## **SOILS AND GEOLOGY STUDY**

**Windermere Subdivision  
El Paso County, Colorado**

**JOB NO. 162062**

**October 26, 2020**

SHEET No. FIG-4

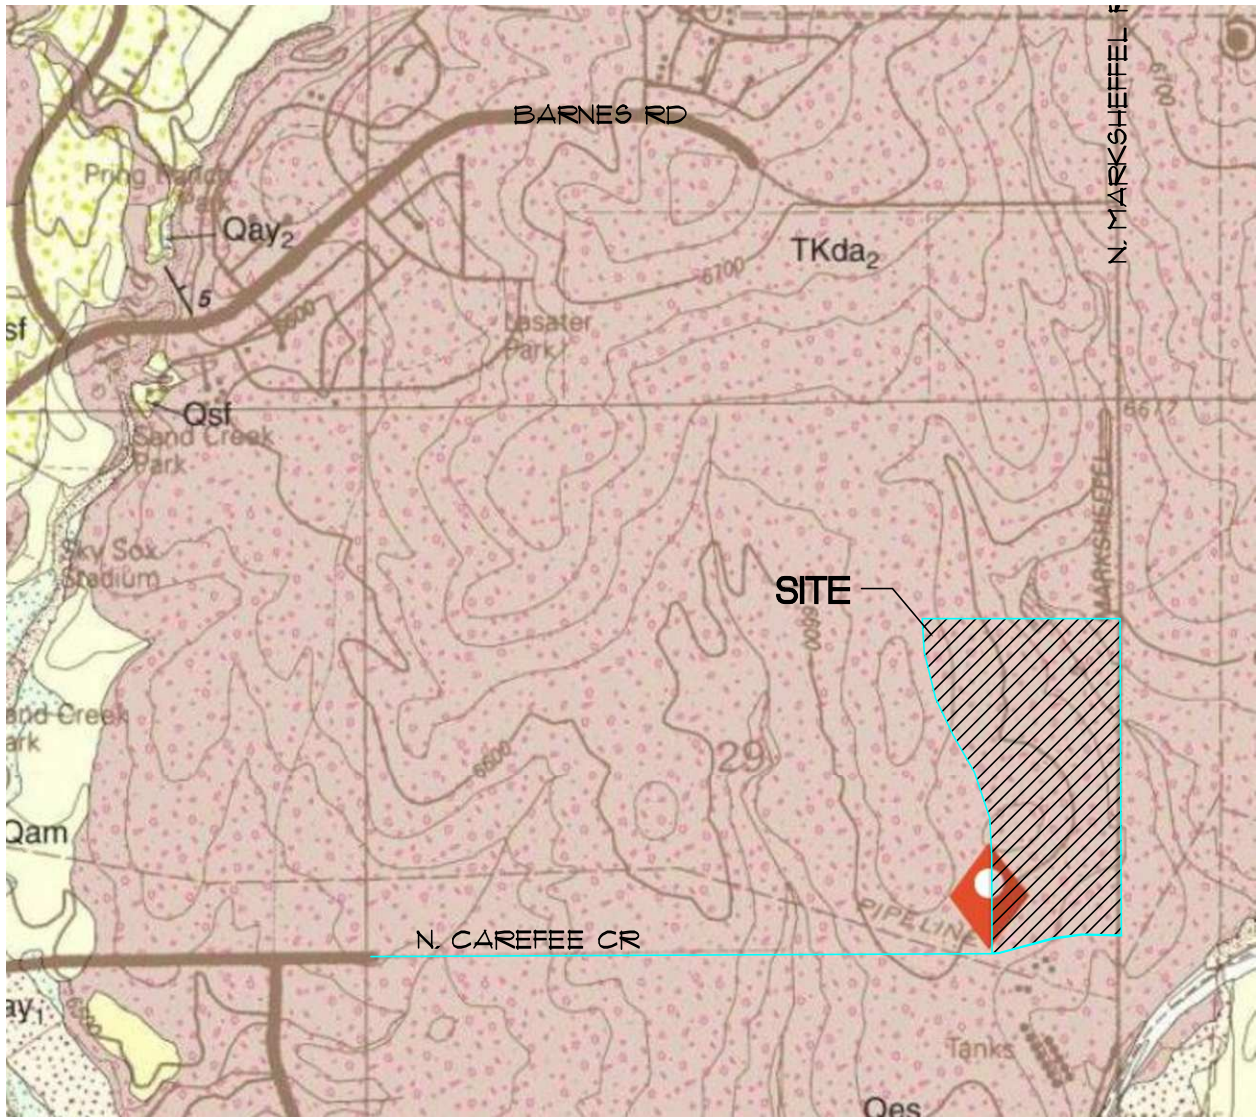
With the indication of seasonally shallow groundwater near the existing detention pond, full-depth basements are not recommended on Lots 72-74, and 169-173.
